Nebraska Public Power District

NLS2011071
September 16, 2011

Subject: Nebraska Public Power District - Cooper Nuclear Station
Docket No. 50-298, License No. DPR-46
License Amendment Request for Implementing a 24-Month Fuel Cycle and
Adoption of TSTF-493, Revision 4, Option A

SR 3.1.7.8 and SR 3.1.7.9

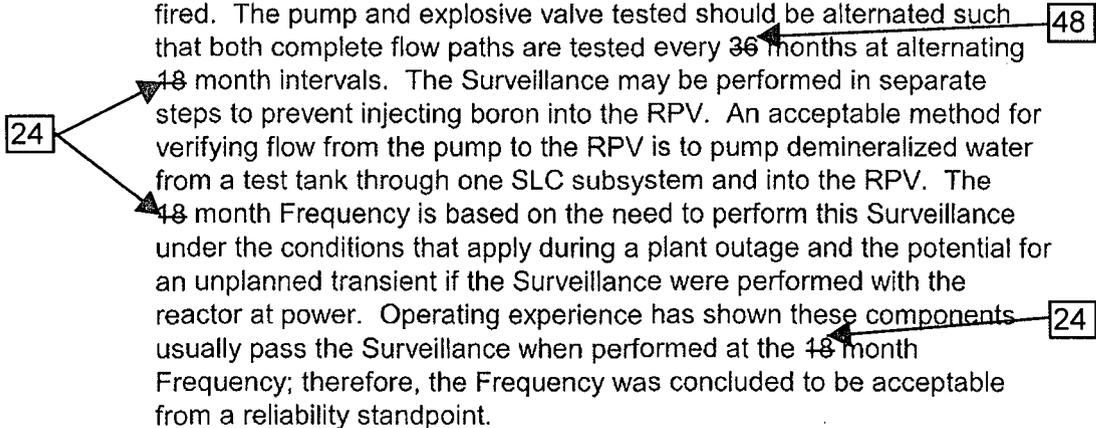
These Surveillances ensure that there is a functioning flow path from the boron solution storage tank to the RPV, including the firing of an explosive valve. The replacement charge for the explosive valve shall be from the same manufactured batch as the one fired or from another batch that has been certified by having one of that batch successfully fired. The pump and explosive valve tested should be alternated such that both complete flow paths are tested every 36 months at alternating 18 month intervals. The Surveillance may be performed in separate steps to prevent injecting boron into the RPV. An acceptable method for verifying flow from the pump to the RPV is to pump demineralized water from a test tank through one SLC subsystem and into the RPV. The 18 month Frequency is based on the need to perform this Surveillance under the conditions that apply during a plant outage and the potential for an unplanned transient if the Surveillance were performed with the reactor at power. Operating experience has shown these components usually pass the Surveillance when performed at the 48 month Frequency; therefore, the Frequency was concluded to be acceptable from a reliability standpoint.

Demonstrating that all heat traced piping between the boron solution storage tank and the suction inlet to the injection pumps is unblocked ensures that there is a functioning flow path for injecting the sodium pentaborate solution. An acceptable method for verifying that the suction piping is unblocked is to manually initiate the system, except the explosive valves, and pump from the storage tank to the test tank. Upon completion of this verification, the pump suction piping must be flushed with demineralized water to ensure piping between the storage tank and pump suction is unblocked. The 48 month Frequency is acceptable since there is a low probability that the subject piping will be blocked due to precipitation of the boron from solution in the heat traced piping. This is especially true in light of the temperature verification of this piping
